Bypass Traffic [Mis-]Projections

10th Street

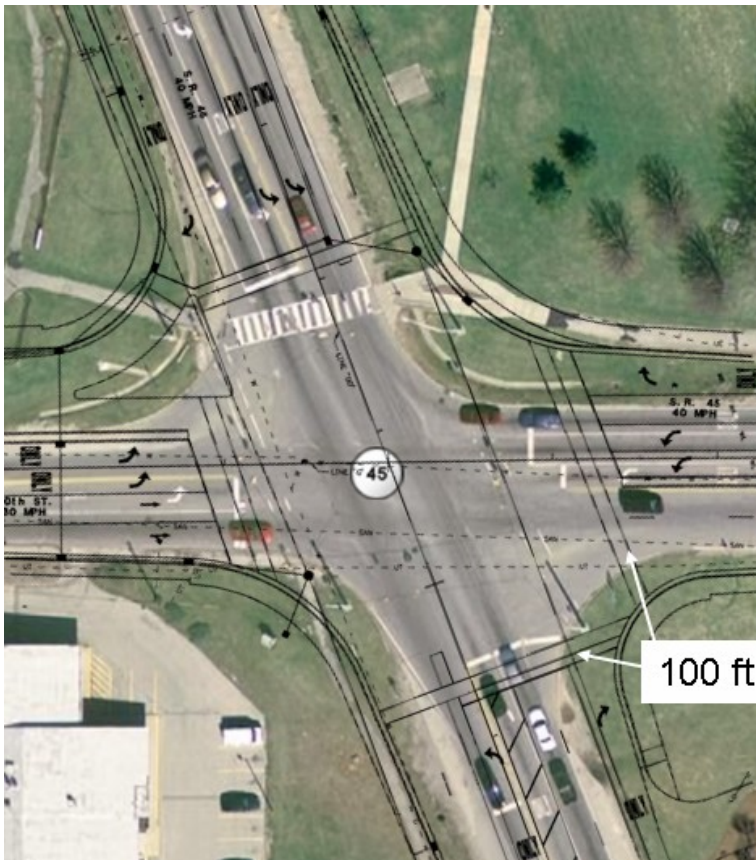
Also, IU has increased the employment and classroom space on the 10th and Bypass location. Many students and employees will need transit access to this area, which requires safe pedestrian access to make it work. To continue this desirable trend of transit growth, it is imperative that this area not become so car-oriented and pedestrian-hostile that the trend cannot continue.

This intersection design and the resulting travel speeds will make this intersection significantly more dangerous than it currently is. To the north, there will be 3 more lanes and conflict points to cross, and 2 additional lanes and conflict points to cross at all the other intersection legs. Speeds will be higher and traffic will be higher from induced demand.

People will feel compelled to drive because walking across this high-speed, pedestrian-hostile street will be too intimidating and dangerous. Thus, transit and walking will decline, while under current conditions they are increasing.

3rd Street

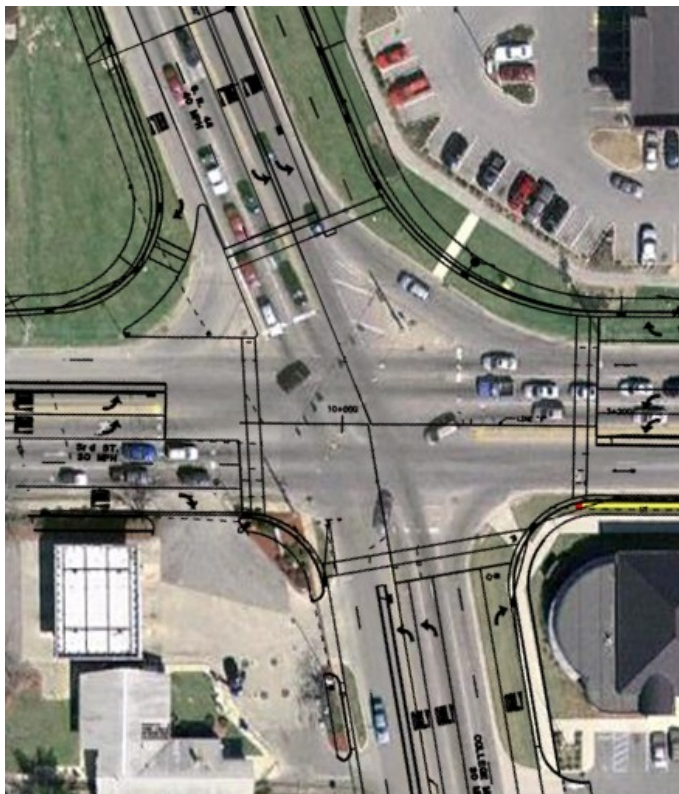
For 3rd and the Bypass, likewise, the growth of retail to the northwest has encouraged significant pedestrian traffic. A pedestrian study showed there were 253 crossings in a 9 ½ hour period. Extrapolation suggests about 400 pedestrian crossings per day at the intersection.

These are very urban environments, but the design actively stifles local traffic. This intersection also increases the crossing distances and conflict points by 2 lanes every direction. There will be a tremendous disincentive to walk, even though many people live within a mile of shopping and employment opportunities in this area.

Both of these intersections have double left turns. Not only are these intimidating to pedestrians, but downstream infrastructure is not designed to handle it. To the east, 10th St was to be widened to handle double left-turns, but

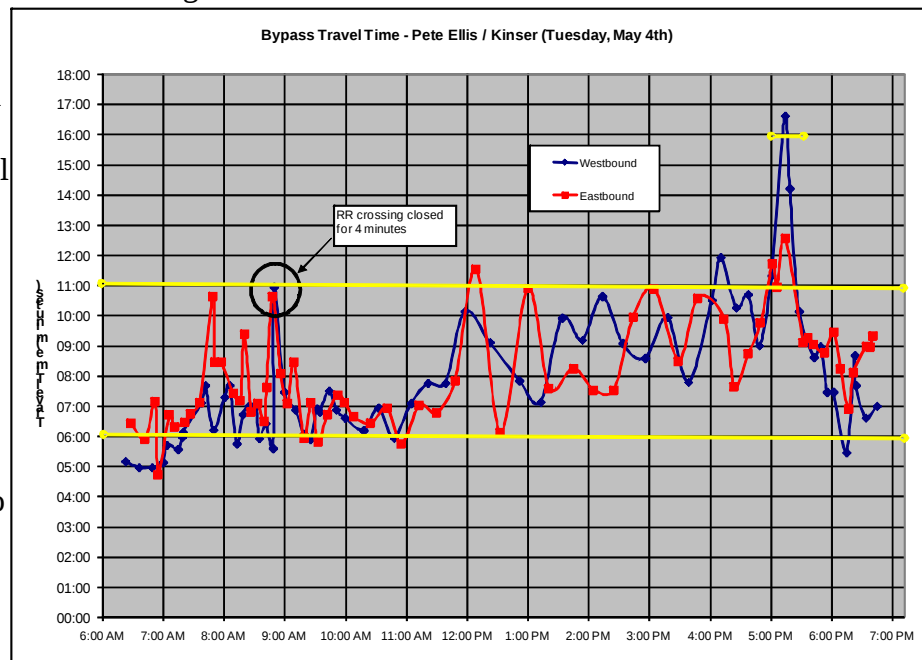
Even the small roads along the bypass are designed for only vehicle convenience. The new 7th street intersection to the east of the bypass, which has only 3 lanes to cross, is massive. The crossing could be only 36 ft in length with 12 ft lanes, but the turning radii are so large they allow cars to turn at high speeds and the crossing approaches 100 ft, putting pedestrians in significant and unnecessary peril.
